Access Compliance Report

Public Rights-of-Way

Intersection ID: 28364	Main Street: HIGHLANDS_CROSSING_DR	Cross Street: SOUTHAMPTON_COMMONS_DR	Location: SW
ADA ID: B12185095E22	Ramp Type: PerpDiag	Initial Pass/Fail: Fail	Overall Compliance: No
Severity Score: 17.5			
Codes/Mitigation Info/Possible Solution		Field Measurements/Component Compliance

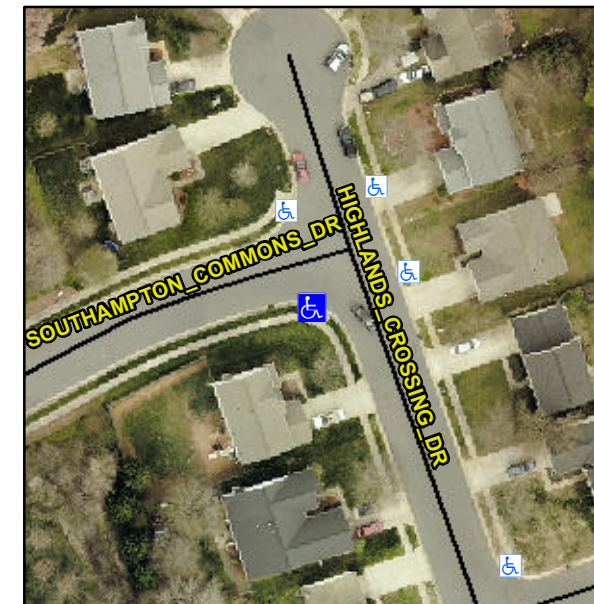
Not Found, R304.5.1

Compliance	Description	Data	Compliance	Description	Data
N/A	Ramp Length (in)	47.0	Yes	Ramp Slope (%)	7.7
No	Ramp Width (in)	35.0	Yes	Ramp XSlope (%)	0.9
N/A	Flare Type LT	N/A	N/A	Flare Type RT	N/A
N/A	Flare Slope LT (%)	N/A	N/A	Flare Slope RT (%)	N/A
N/A	Flare Traversable LT?	N/A	N/A	Flare Traversable RT?	N/A
N/A	Landing Length (in)	N/A	N/A	DWS Provided?	N/A
N/A	Landing Width (in)	N/A	N/A	DWS Contrast?	N/A
N/A	Landing Slope (%)	N/A	N/A	DWS Length (in)	N/A
N/A	Landing X Slope (%)	N/A	N/A	DWS Full Width?	N/A
N/A	Landing Curb? (Y/N)	N/A	N/A	DWS Offset (in)	N/A
N/A	Shared Landing?	N/A			
N/A	Gutter Ponding?	N/A	N/A	Gutter Slope (%)	N/A
N/A	Gutter Lip Ht (in)	N/A	N/A	Gutter X Slope (%)	N/A
N/A	Painted X Walk1?	No	N/A	Painted X Walk2?	No
	X Walk 1 Direction	To E		X Walk 2 Direction	To N
N/A	X Walk 1 Width (in)	N/A	N/A	X Walk 2 Width (in)	N/A
	X Walk 1 Slope (%)	5.0		X Walk 2 Slope (%)	3.8
	X Walk 1 X Slope (%)	2.3		X Walk 2 X Slope (%)	4.0

Remove & Replace Curb Ramp With Two New Directional Ramps or Equivalent.
